RS-03-081

Clinton Power Station, Unit 1  
Facility Operating License No. NPF-62  
NRC Docket No. 50-461

Subject: Request for License Amendment for Core Flow Operating Range Expansion and Oscillation Power Range Monitor (OPRM) Instrumentation

Figure 3.4.1-1 (page 1 of 1)  
Thermal Power/Core Flow Stability Regions

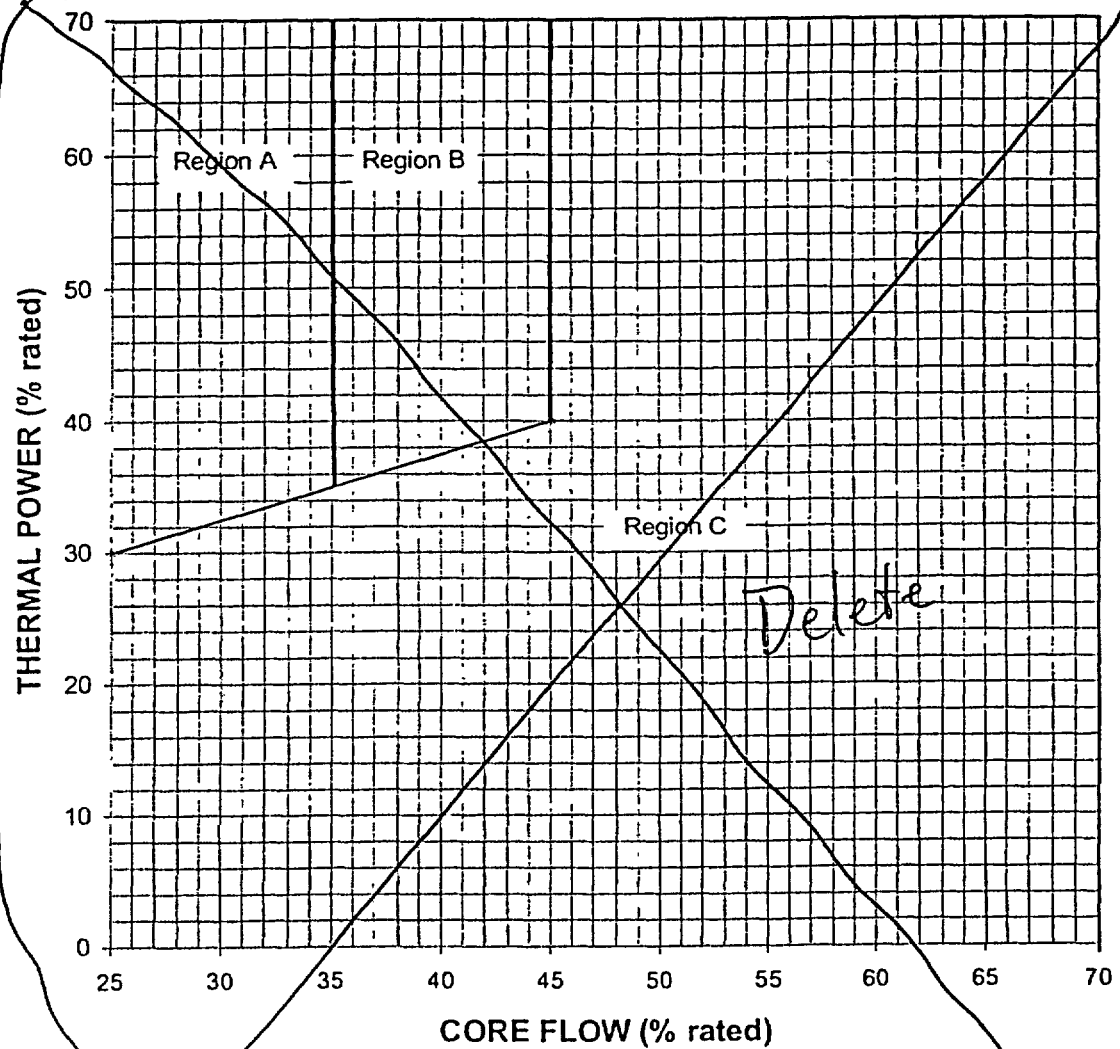
Due to the automatic scram functions provided by the OPRM instrumentation, the manual operator actions specified in TS Section 3.4.1 (and its associated Conditions, Actions, and Surveillance Requirements), which are required to be taken upon entry into a specified region of the power-to-flow map, are being removed. The removal of these references includes elimination of LCO items 3.4.1.A.2, B.2 and B.3, LCO Note, removal of Actions B, C, D, G.1 and G.2, as well as deletion of SR 3.4.1.2 and Figure 3.4.1-1.
